PCN # 2025007		Issued Date 08/26/2025	
PCN Title Amphenol M12 to RJ45 Cat6a cable update.			
Document Version 1.0		Customer Contact Sales@thinklucid.com	
PCN TYPE	<input checked="" type="checkbox"/> Electrical Specification	<input type="checkbox"/> Regulatory or Compliance	
	<input checked="" type="checkbox"/> Mechanical Specification	<input type="checkbox"/> Part Number Change	
	<input type="checkbox"/> Optical Specification	<input type="checkbox"/> End of Life	
	<input type="checkbox"/> Firmware Specification	<input type="checkbox"/> Other	
Affected Part Number(S)			
PART NUMBER		DESCRIPTION	
CAB-MR-2M-A		Amphenol M12-RJ45 CAT6A IP67 Cable 2M	
CAB-MR-5M-A		Amphenol M12-RJ45 CAT6A IP67 Cable 5M	
CAB-MR-15M-A		Amphenol M12-RJ45 CAT6A IP67 Cable 15M	
CAB-MR-5M-RA1-A		Amphenol M12-RJ45 CAT6A IP67 Cable 5M (RA1)	
CAB-MR-5M-RA2-A		Amphenol M12-RJ45 CAT6A IP67 Cable 5M (RA2)	
CAB-MR-5M-RA3-A		Amphenol M12-RJ45 CAT6A IP67 Cable 5M (RA3)

Reason and Description of the Product Change

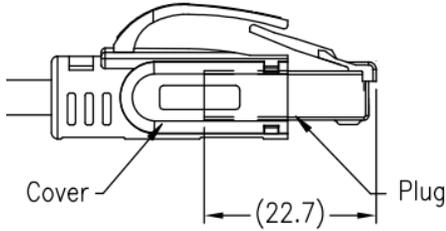
LUCID has received reports of faulty right-angled M12 to RJ45 Amphenol cables that prevent LUCID 10 GigE cameras from achieving full 10 GigE bandwidth. Upon evaluation, the issue was traced to poor assembly of the right-angled M12 connector. Specifically, the cable gland separating the wire pairs was not implemented, unshielded sections were not minimized, and one pair even formed a loop. These factors likely increase crosstalk and interfere with PHY equalization, leading to performance degradation.

To address the issue, the cable vendor will implement updates to the M12 to RJ45 cables by using a new cable wire and modifying the assembly process for the right-angled M12 connectors. Additionally, extra testing will be implemented to identify cables with defective right-angled M12 connectors. As part of this update, the RJ45 boot design will also be revised.
